Agenda – Executive Policy Committee – January 19, 2022

Item No. 2 Development Agreement Amendment – File DASZ 10/2013 (AG 10/13) (Transcona Ward)

Title: Development Agreement Amendment – File DASZ 10/2013 (AG 10/13)

SCHEDULE 'G'

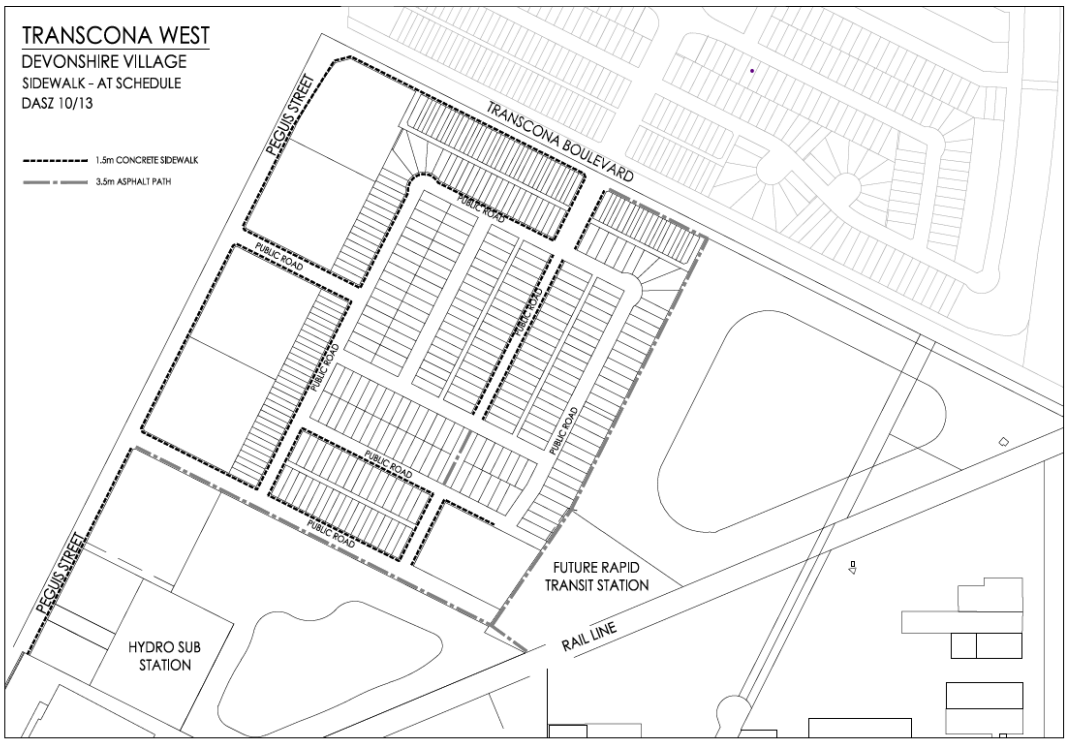
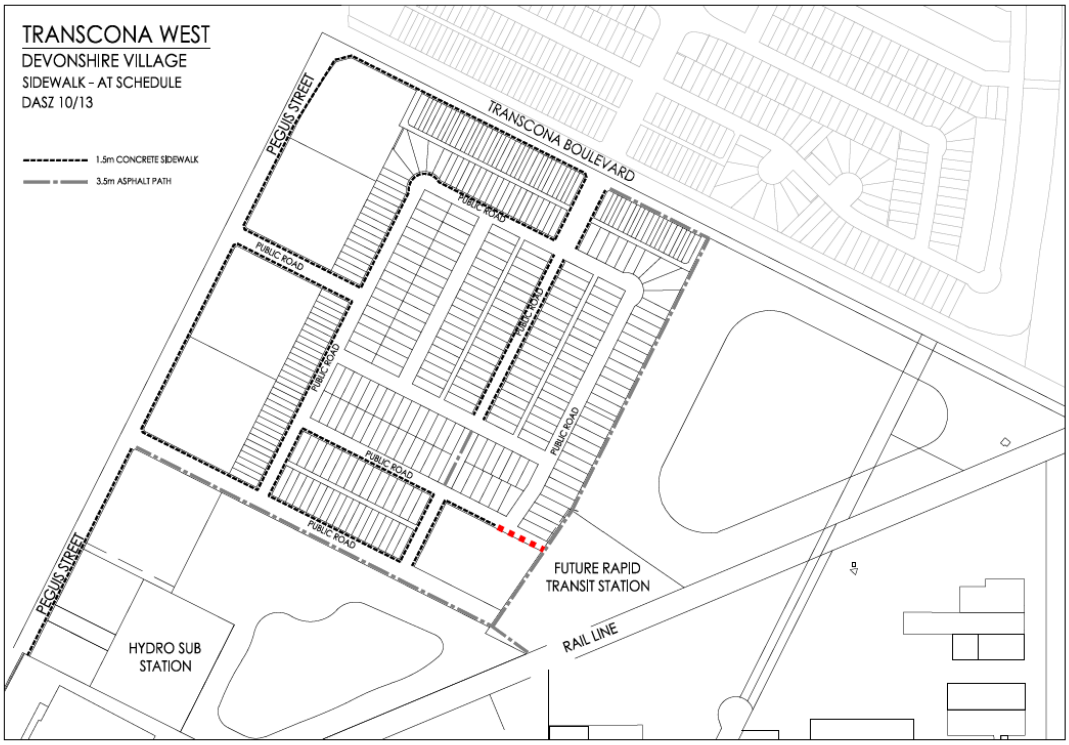
The Developer has submitted a request to amend AG 10/13 (Appendix A) to eliminate the pathway connection due to concerns with the existing grading in the area and adherence to universal design standards.

- Amend Schedule "G" to:
  Remove the requirement for a sidewalk connection from Larry Vickar Drive East to the Deep Pond AT pathway (as shown on the attached map).

Comments
The objective of the proposed amendment is to delete the sidewalk connection from Larry Vickar Drive East to the deep pond AT pathway. This connection is redundant as there is east-west connection to the deep pond AT path along Transcona Boulevard to the north and Cal Gardner Drive to the south. This specific agreement provision was added by the City during the public hearing for DASZ 10/13 without opportunity to fully review the feasibility of the requirement in relation to site characteristics. The existing grades in the area do not make it reasonable or possible to construct the public walkway to universal design standards. As such, Genstar is proposing that the sidewalk be removed and replaced with an informal, low maintenance granular pathway. The surrounding public reserve area will be developed with low/no maintenance naturalized plantings and grasses, and landscaping boulders. The intent is to provide an informal and passive connection to the deep pond AT path while using design interventions to discourage unsafe travel.

B. Delete Schedule G in its entirety, and replace with “Revised Schedule G” attached to this report as “Appendix B”,

REVISED SCHEDULE G
